Attachment 1 Report No. DS-2024-0045 23349 Woodbine Avenue Page 1 of 1

Re: Request for Conditions – 3<sup>rd</sup> Submission - Draft Plan of Subdivision 01.162 (SUBP.23.G.0006) and Zoning By-Law Amendment 03.1174 (ZBA.23.G.0013) Part Lots 3 & 4, Concession 4 23349 Woodbine Avenue (Maria Calderaro) Town of Georgina

## LSRCA CONDITIONS OF DRAFT PLAN APPROVAL May 3, 2024 23349 Woodbine Ave Town of Georgina, York Region LSRCA File SD-167784-020123

The following comments are in regard to the provided Landscape Plans and Arborist Report for applications 01.162 & 03.1174 and have considered the Town of Georgina Keswick Business Park Appendix A- Urban Design Guidelines, Tree Preservation and Compensation Policy, and the Maskinonge River Subwatershed Plan. These comments replace the ones submitted dated July 2, 2025, from J. Burns.

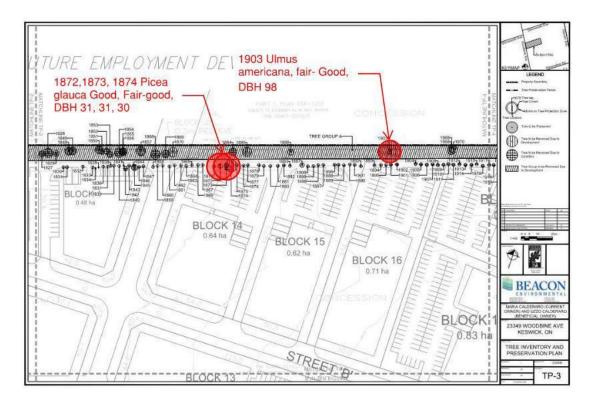
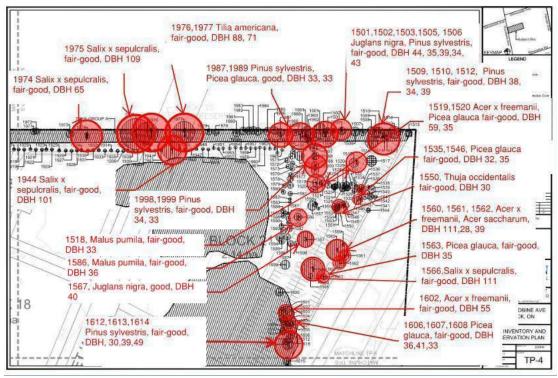
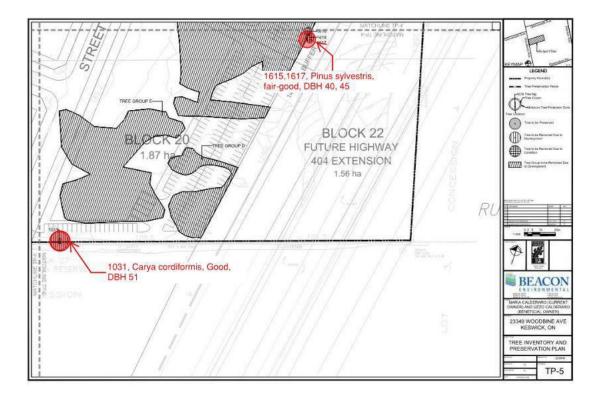
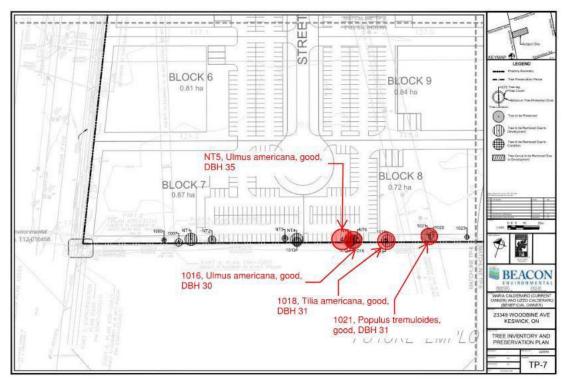
- 5. The owner should examine opportunities to retain additional tress on-site. We've identified based on the concept plan where these opportunities may exist and any additional trees that are retained, would reflect an adjustment to the compensation owed. We recognize that this may not be possible given the nature of site grading and pre-servicing works. See notations on the Landscape Concept Plan provided below.
